HISTORIC AND DESIGN REVIEW COMMISSION

HDRC CASE NO: 2017-550
ADDRESS: 213 SWEET
LEGAL DESCRIPTION: NCB 2558 BLK E LOT 12
ZONING: RM-4
CITY COUNCIL DIST.: 1
DISTRICT: Nathan Historic District
APPLICANT: Sylvia Trevino
OWNER: Cristela Canales
TYPE OF WORK: Rehabilitation and New Addition
APPLICATION RECEIVED: October 27, 2017
60-DAY REVIEW: December 26, 2018

1. Construct a two story, rear addition to the historic structure located at 213 Sweet Street in the Nathan Historic District.
2. Demolish an existing, rear accessory structure.

SITE PLAN

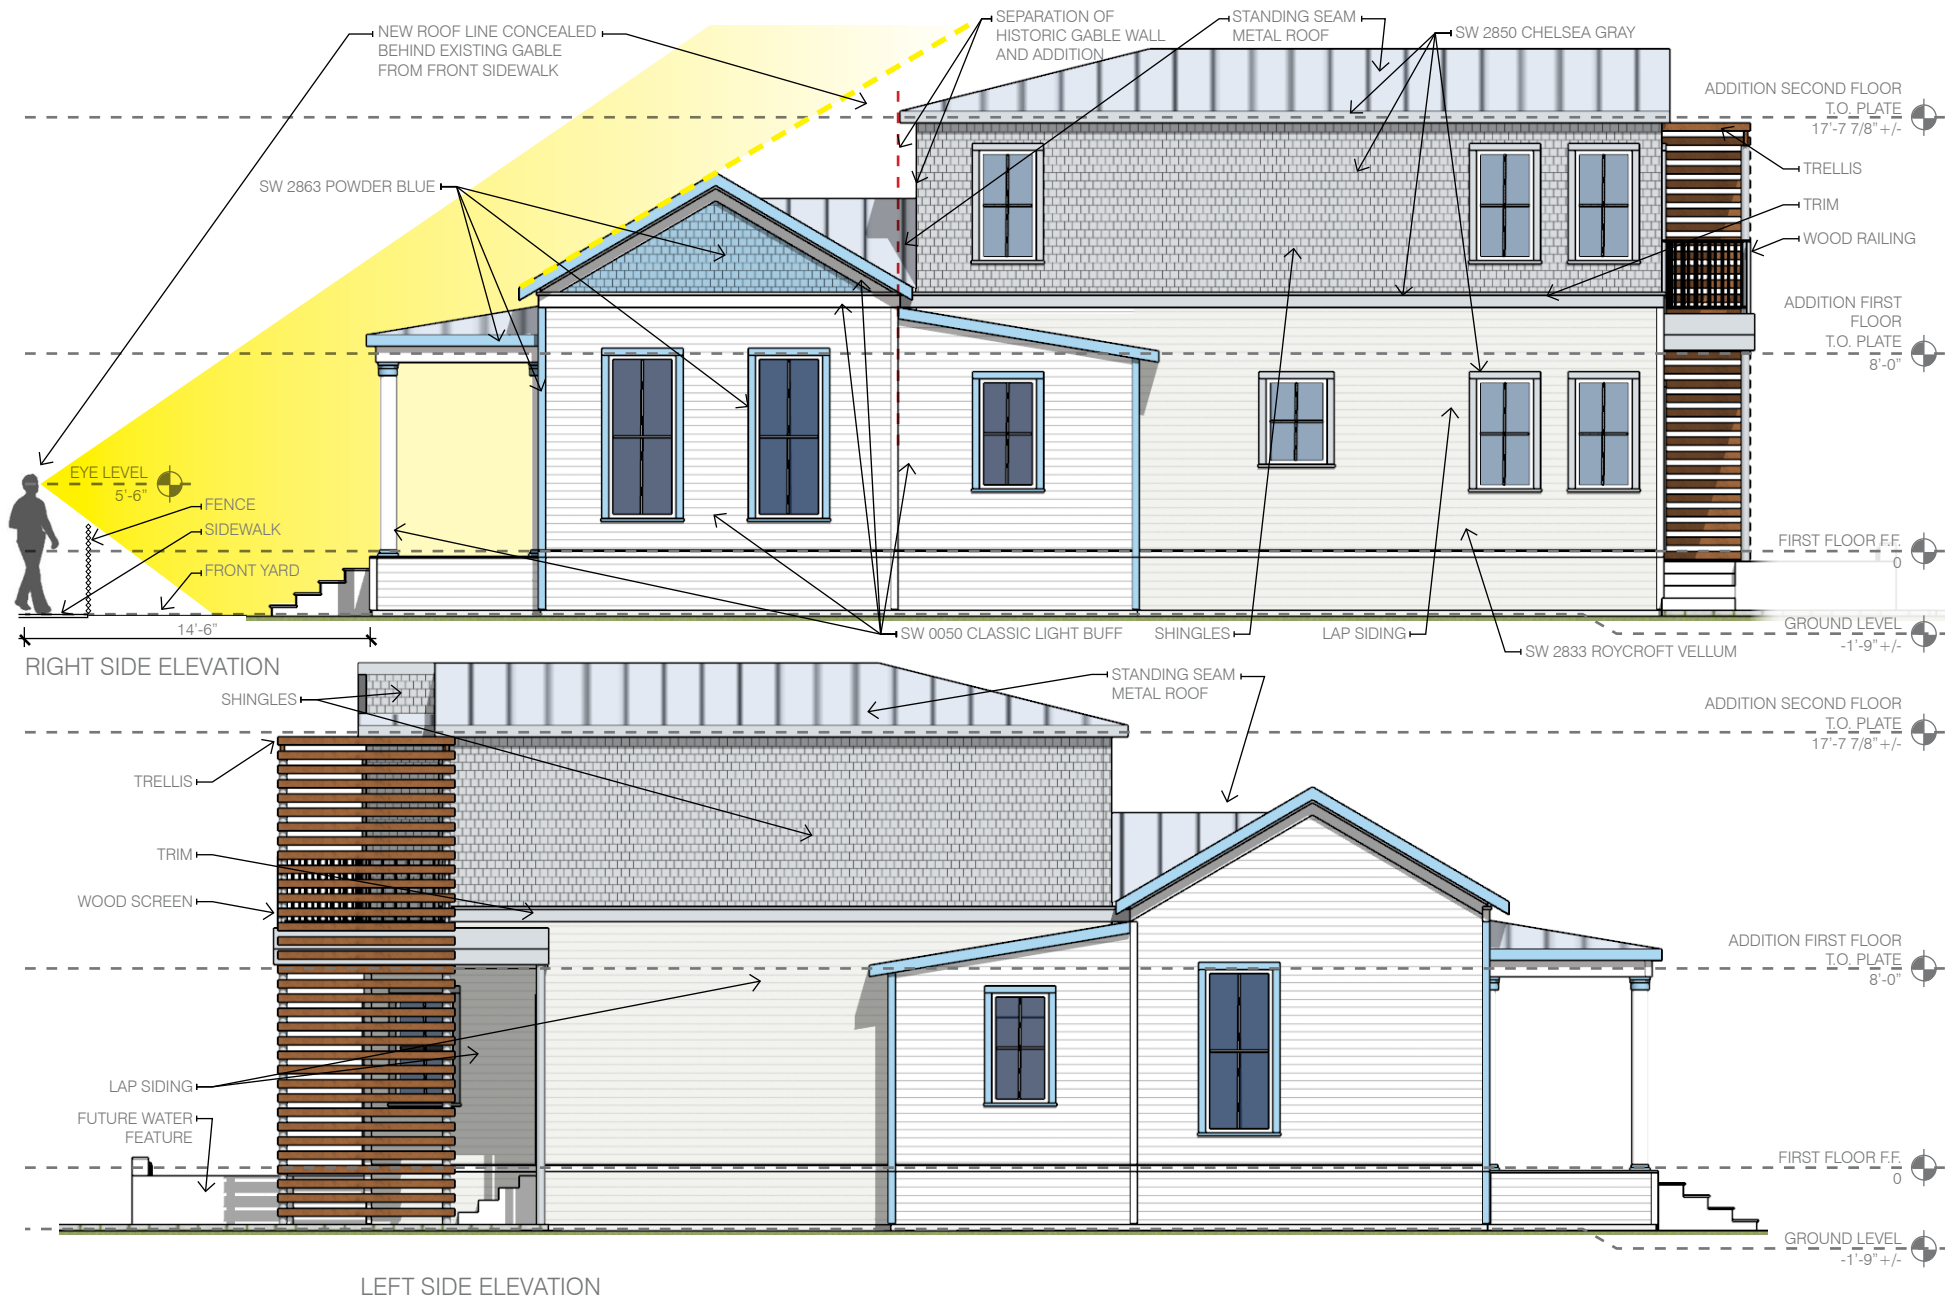
- c. REAR ACCESSORY STRUCTURE – The lot at 213 Sweet features a rear accessory structure, which in its current location matches the location of an accessory structure found on the 1952 Sanborn Map. The applicant has proposed to demolish this rear structure. The structure features materials that are historic to the district such as wood board and batten siding and an original standing seam metal roof. Staff finds the structure to be contributing to the site and does not recommend approval of its removal.

- iv. That every attempt be made to preserve the historic accessory in place. If the HDRC approves its removal, then the materials should be salvaged and reused where possible.

ELEVATIONS

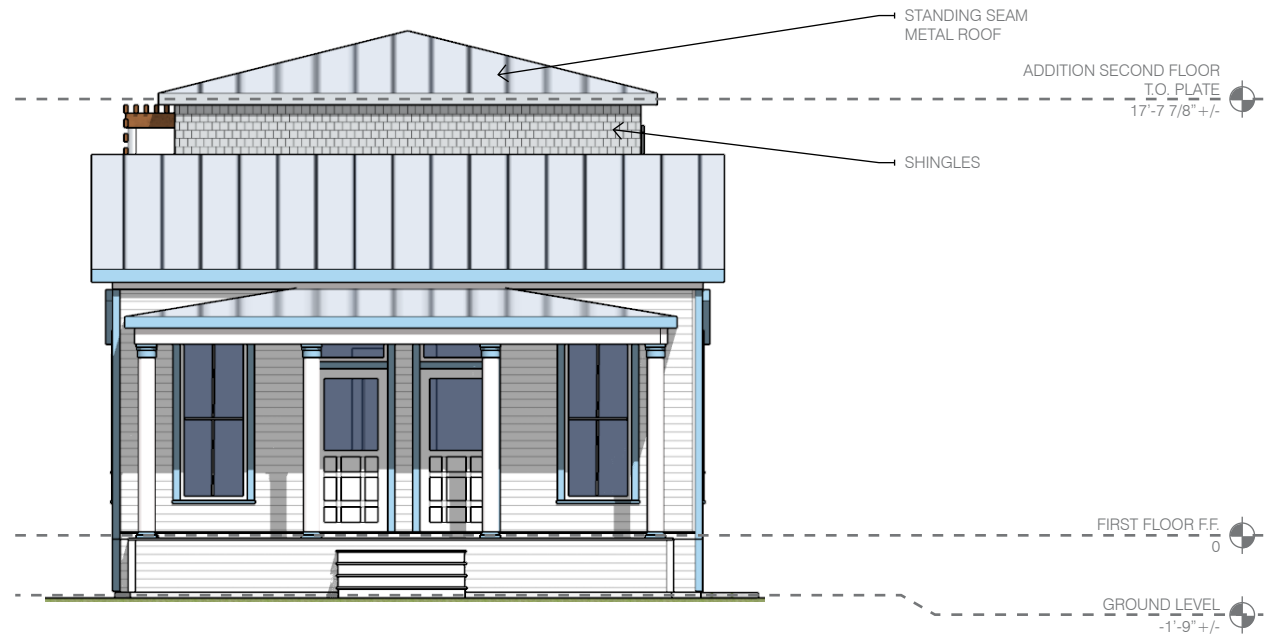
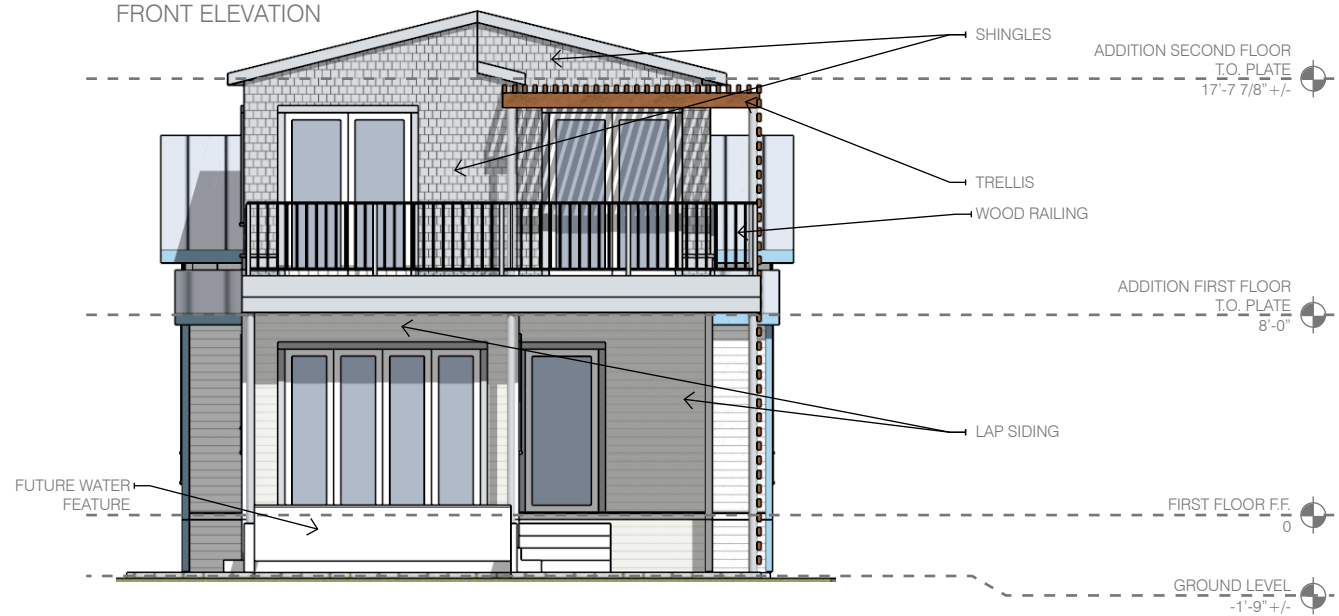
- e. ROOF FORM – The applicant has proposed a hipped roof facing Sweet Street, complementary of that of the historic structure's porch and a rear gabled roof facing the rear alley. Staff finds the overall proportion and form of both roof forms to be architecturally appropriate and consistent with the Guidelines 1.A.

- g. **SCALE, MASS & FORM** – Regarding scale, mass and form, the applicant has proposed an addition that features a footprint that is 68 percent of the footprint of the historic structure and features two stories whereas the historic structure only features one. While the proposed footprint and height are not consistent with the Guidelines, staff finds that application documents provided by the applicant such as perspectives note that the proposed addition will not necessarily overwhelm the historic structure. Staff finds that the separation between the two structures should be increased to further reduce the perceived massing of the addition if a complete separation was proposed between the second story of the addition and the rear slope of the historic side gable. The roof structure that connects to the rear slope of the historic structure’s side gable should be reduced in height to be subordinate to the height of the historic structure’s ridge line and the east wall of the proposed second story should start clear of the rear of the historic, side facing gable.

- i. That the separation between the proposed addition and historic structure be increased to further reduce the perceived massing of the addition through a complete separation between the second story of the addition and the rear slope of the historic roof. The roof ridge height of the new structure that connects to the rear slope of the historic roof to the addition should be reduced to be subordinate to the historic structure’s ridge line. The east wall of the proposed second story should not interrupt the roof line of the historic structure.

ROOF PLAN

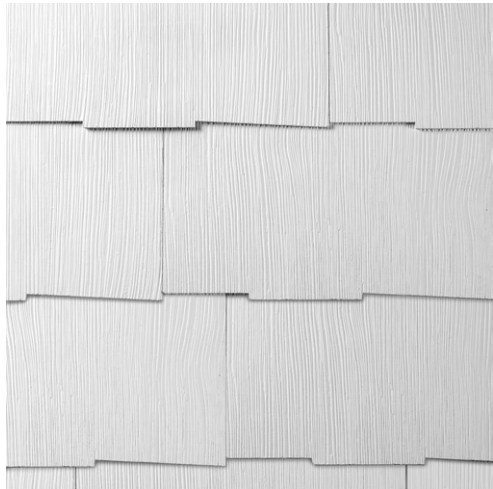
- h. **MATERIALS** – The applicant has proposed materials that include a standing seam metal roof, fiber cement lap siding, fiber cement shingle siding, fiberglass doors, and two over two windows of which a material has not been specified. The proposed siding should feature a smooth finish and a four inch profile. The proposed standing seam metal roof should feature panels that are 18 to 21 inches wide, seams that are 1 to 2 inches in height, a crimped ridge seam and a galvalume finish.

- ii. That the fiber cement siding feature a smooth finish and a four inch profile and that the proposed standing seam metal roof feature panels that are 18 to 21 inches wide, seams that are 1 to 2 inches in height, a crimped ridge seam and a galvalume finish.
